Wisconsin Department of Transportation

Proposal #09: 1130-44-74, WISC 2024402
Appleton – Green Bay
Wrightstown SWEF 34/Post-Bldg
IH 41
Outagamie County

This is Addendum No.02, which provides for the following:

1 ENLARGED 115 MECHANICAL ROOM
M300
1/4" = 1'-0"

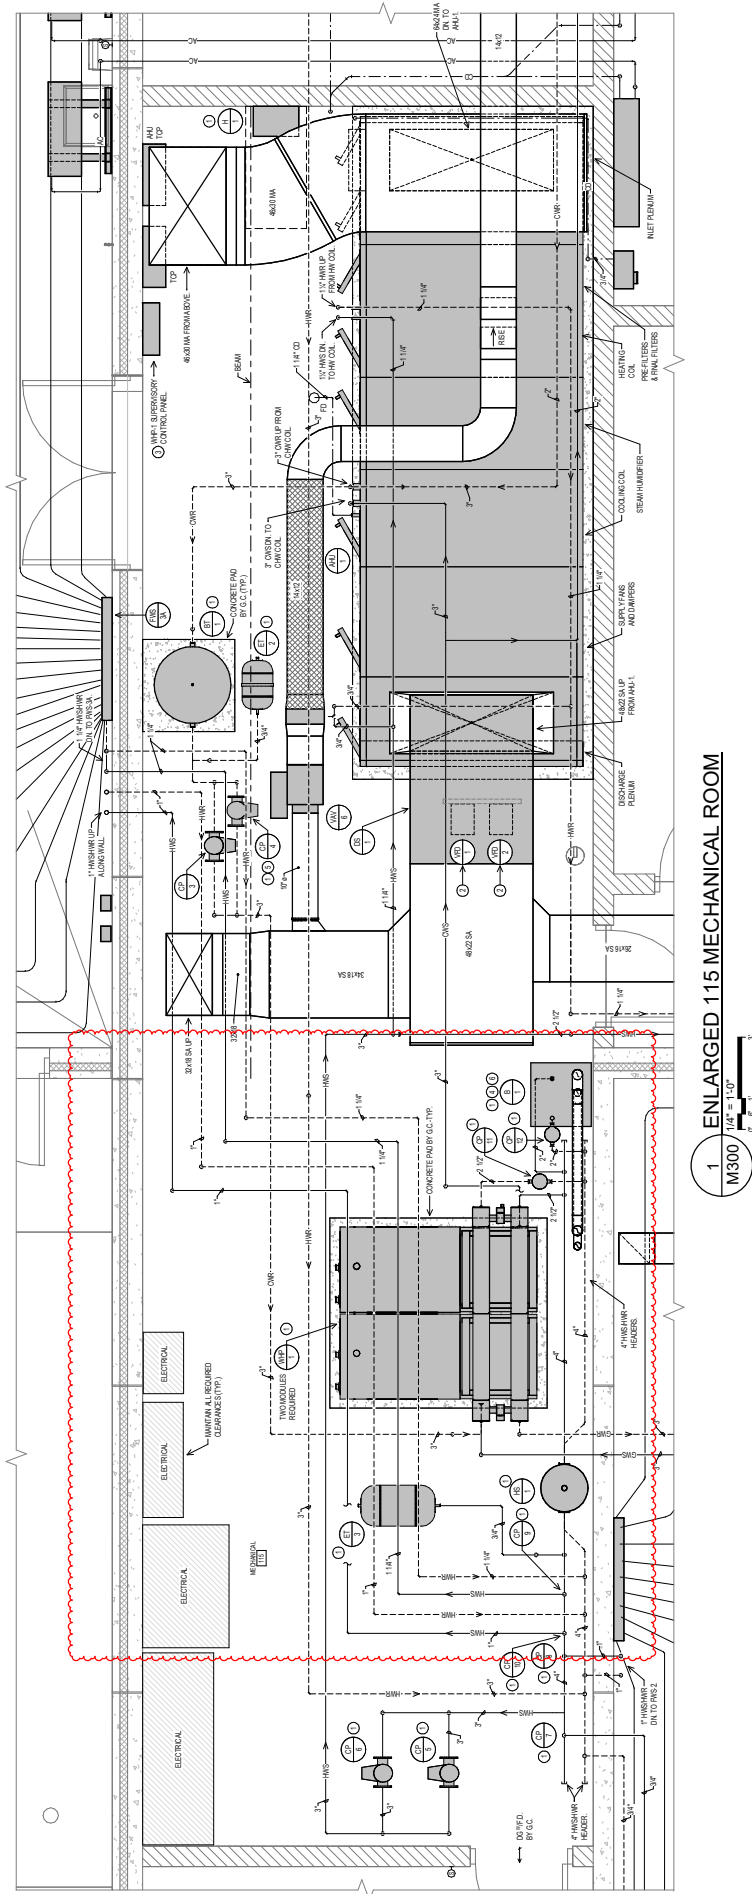
Revised Plan Sheets	
Plan Sheet	Plan Sheet Title (brief description of changes to sheet)
297	Revised piping detail
302	Revised mechanical room layout detail
311	Revised hot water system detail
